**Town of Upton, MA
Proposed Bridge Replacement
Grove Street over Center Brook
Bridge No. U-01-004 (CRH) Bridge Replacement and
Bridge No. U-01-004 (CRJ) Pedestrian Bridge
Addendum No. 2**

To be considered as part of the contract drawings and specifications for the Proposed Bridge Replacement – Grove Street over Center Brook – Bridge U-01-004 (CRH) and Proposed Pedestrian Bridge – Bridge U-01-004 (CRH). Bidders are advised that this Addendum must be acknowledged in the appropriate space provided on the Form for General Bid.

1. Sheets S-16 – PEDESTRIAN BRIDGE PLAN & ELEVATION and S-17 – PEDESTRIAN BRIDGE DETAILS

**PEDESTRIAN BRIDGE
PLAN & ELEVATION**

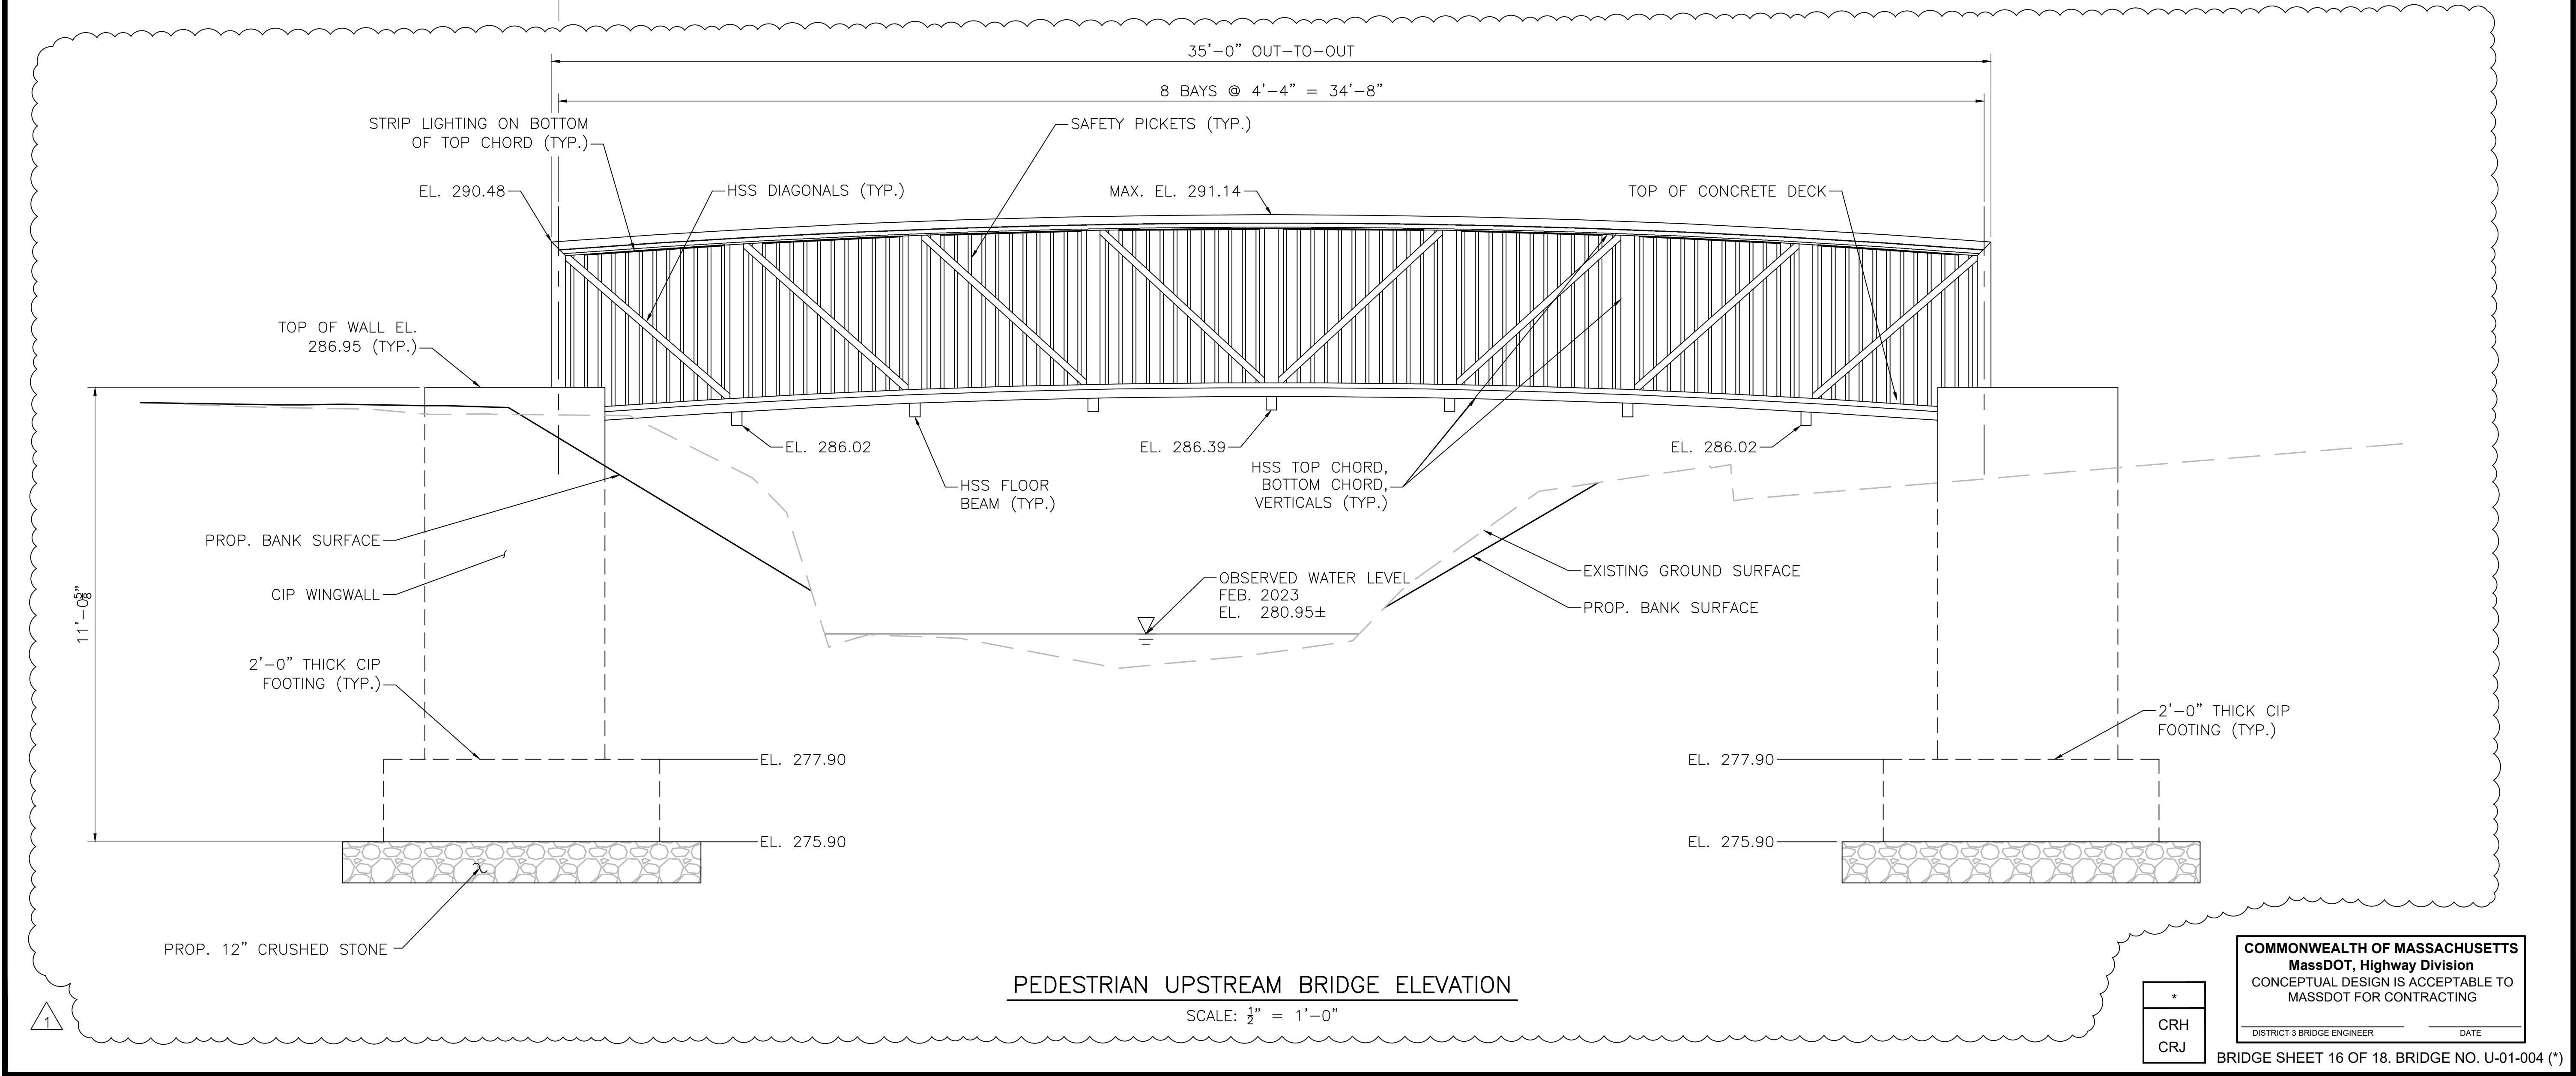
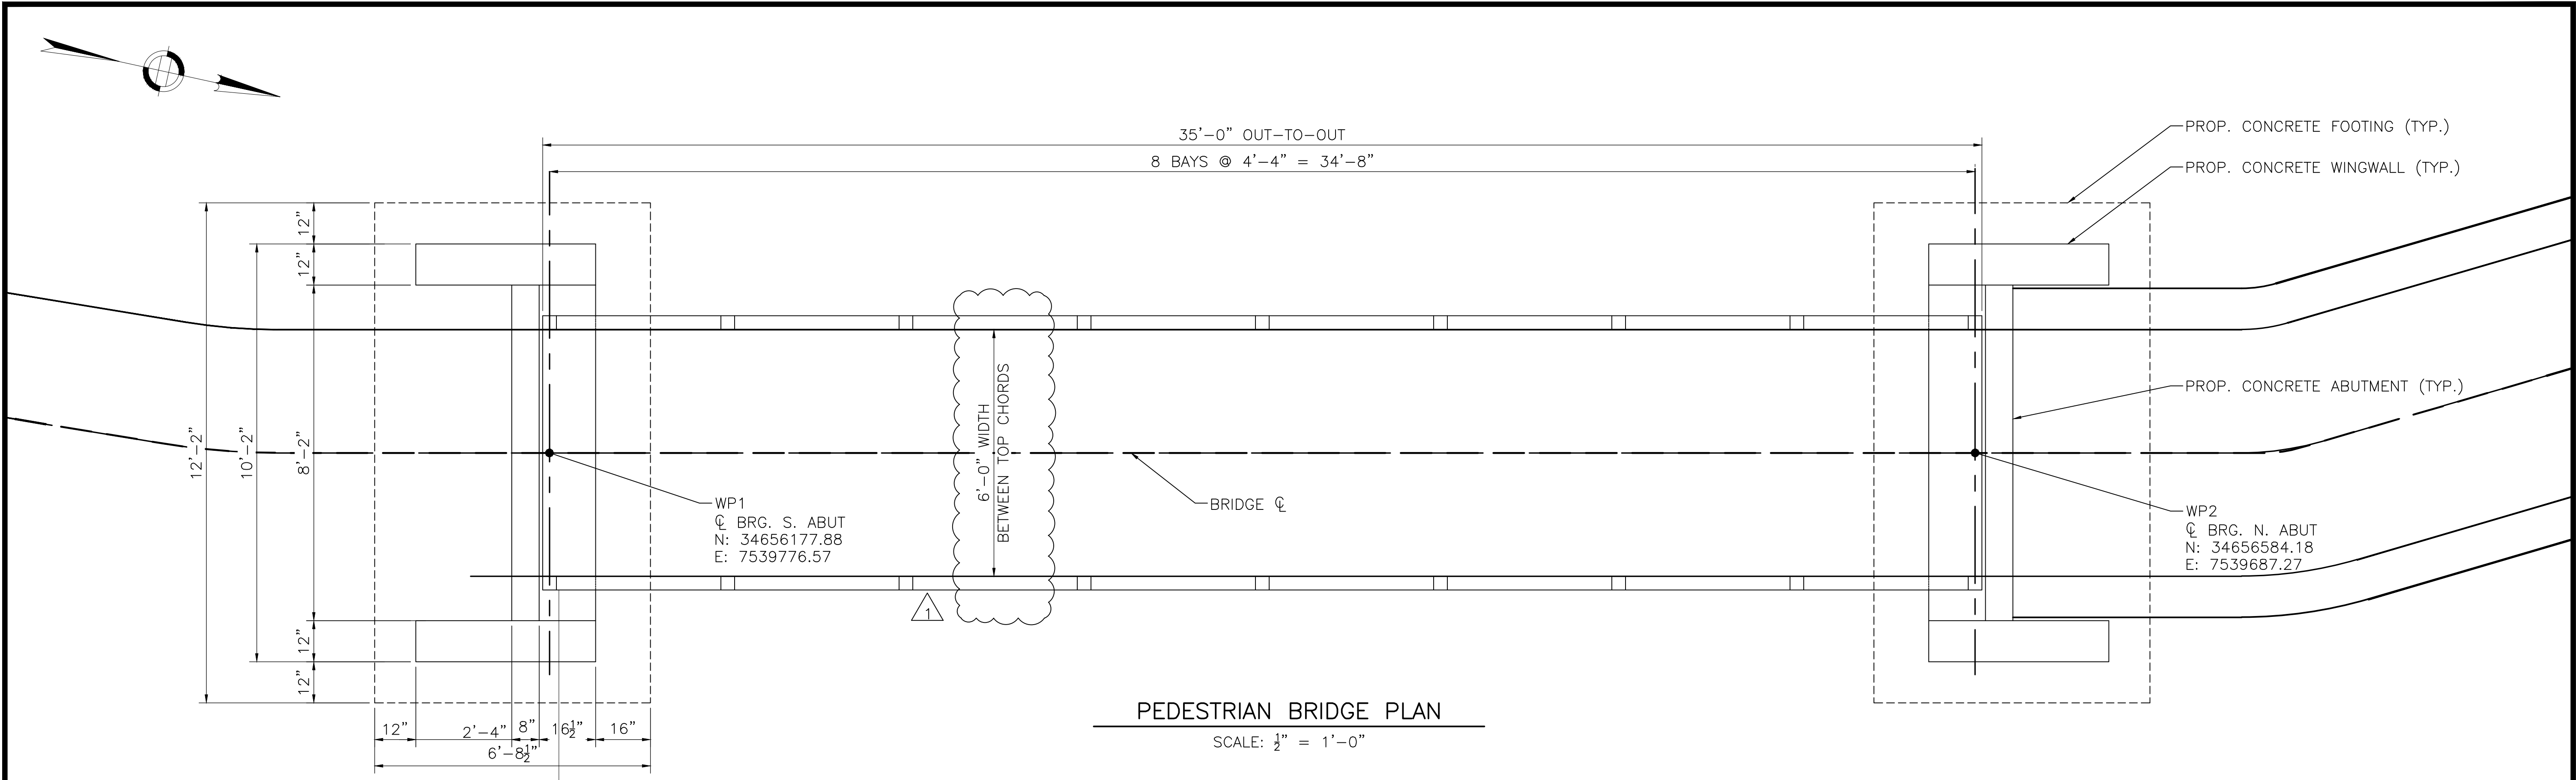
1. DELETE sheet and replace with Sheet S-16, attached at the end of this Addendum. Revised bridge plan to provide clarification on bridge width, revised the elevation to remove member callouts, and added the location of lighting.

- Q9. The bridge plan on sheet S-19 references a 6'-0" clear width. However, the section detail on sheet S-17 shows the 6'-0" dimension as being measured between face of top chords, which will result in a clear width of less than 6'-0" between the handrails. Please clarify.

- Q10. Note #1 on sheet S-17 indicates that the pedestrian bridge is to be designed by the bridge manufacturer, however the plans also provide member sizes and bay spacings. Do either of those design aspects need to be held, or does the bridge manufacturer have the flexibility to make adjustments?

A3. The pedestrian bridge designer is allowed to use alternate member sizes, as needed, then what is shown on the plans while adhering to the design parameters indicated on the plans and special provisions. Any proposed alterations will be reviewed during the shop drawing review process. Sheet S-16 and Sheet S-17 have been revised to remove the member sizes.

- A6. Bridge lighting is required. Sheets S-16 and S-17 have been revised to show location of lighting on the pedestrian bridge. The electrical drawings will be provided in an upcoming Addendum.
- Q7. The drawings and specifications indicate that HMA is required for driveways and a sidewalk to the pedestrian bridge. However, the Bid Form does not provide items or estimated quantities for that work.

- A9. The 6'-0" dimension shall be between the top chords, as indicated on Sheet S-17. The bridge plan on Sheet S-16 has been revised for clarification.

- A10. The pedestrian bridge designer is allowed to use alternate member sizes, as needed, then what is shown on the plans while adhering to the design parameters indicated on the plans and special provisions. Any proposed alterations will be reviewed during the shop drawing review process. Sheets S-16 and S-17 have been revised to remove the member size callouts.

- A11. Bridge lighting is required. Sheets S-16 and S-17 have been revised to show location of lighting on the pedestrian bridge. The electrical work is covered under special provision 100.5 – ELECTRICAL WORK. The electrical drawings will be provided in an upcoming Addendum.

PEDESTRIAN BRIDGE CROSS-SECTION
SCALE: 1" = 1'-0"

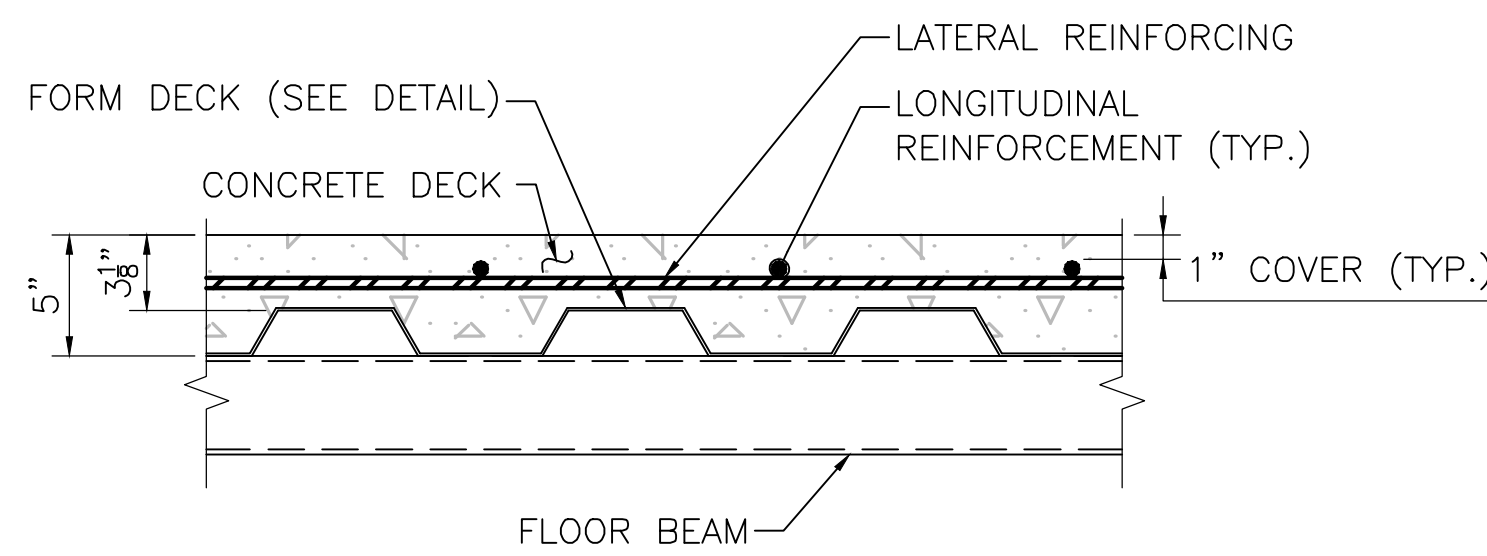
1. DELETE sheet and replace with Sheet S-17, attached at the end of this Addendum. Revised Pedestrian Bridge cross-section to show pickets on the inside of the truss, to remove member callouts, and added the location of lighting.

Q4. In the same Special Provision (995.02 Bridge Structure, Pedestrian Bridge), the ATTACHMENTS subheading states "Safety rail system shall be placed on the inside of the structure...". The plan drawings, Sheet S-17 – Pedestrian Bridge Cross Section, indicate the safety pickets are on the exterior.

A4. The safety rail pickets shall be placed on the inside of the structure, as depicted in the special provisions. Sheet S-17 has been revised to reflect this and has been attached as part of this Addendum.
